# Access Compliance Report

## Public Rights-of-Way

### (Curb Ramps)

Intersection ID: 10671	Main Street: PLYMOUTH_AV	Cross Street: GRIMES_ST	Location:	N
ADA ID: 29559698FE59	Ramp Type: PerpDiag	Initial Pass/Fail: Fail	Overall Compliance: No	Severity Score: 13.75
Codes/Mitigation Info/Possible Solution		Field Measurements/Component Compliance

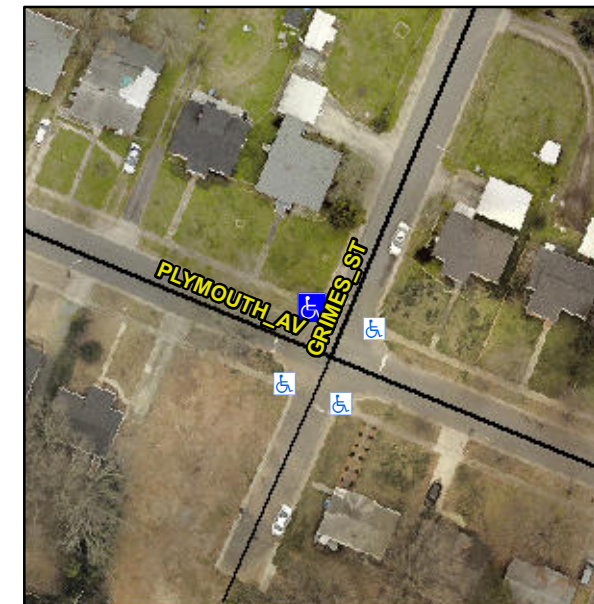
**Not Found, R304.2.2, R304.5.3**

Compliance	Description	Data	Compliance	Description	Data
N/A	Ramp Length (in)	37.5	No	Ramp Slope (%)	9.5
Yes	Ramp Width (in)	48.0	No	Ramp XSlope (%)	2.4
N/A	Flare Type LT	N/A	N/A	Flare Type RT	N/A
N/A	Flare Slope LT (%)	N/A	N/A	Flare Slope RT (%)	N/A
N/A	Flare Traversable LT?	N/A	N/A	Flare Traversable RT?	N/A
N/A	Landing Length (in)	N/A	N/A	DWS Provided?	N/A
N/A	Landing Width (in)	N/A	N/A	DWS Contrast?	N/A
N/A	Landing Slope (%)	N/A	N/A	DWS Length (in)	N/A
N/A	Landing X Slope (%)	N/A	N/A	DWS Full Width?	N/A
N/A	Landing Curb? (Y/N)	N/A	N/A	DWS Offset (in)	N/A
N/A	Shared Landing?	N/A			
N/A	Gutter Ponding?	N/A	N/A	Gutter Slope (%)	N/A
N/A	Gutter Lip Ht (in)	N/A	N/A	Gutter X Slope (%)	N/A
N/A	Painted X Walk1?	No	N/A	Painted X Walk2?	No
	X Walk 1 Direction	To SW		X Walk 2 Direction	To SE
N/A	X Walk 1 Width (in)	N/A	N/A	X Walk 2 Width (in)	N/A
	X Walk 1 Slope (%)	3.6		X Walk 2 Slope (%)	0.2
	X Walk 1 X Slope (%)	2.5		X Walk 2 X Slope (%)	0.4

**Remove & Replace Curb Ramp With Two New Directional Ramps or Equivalent.**
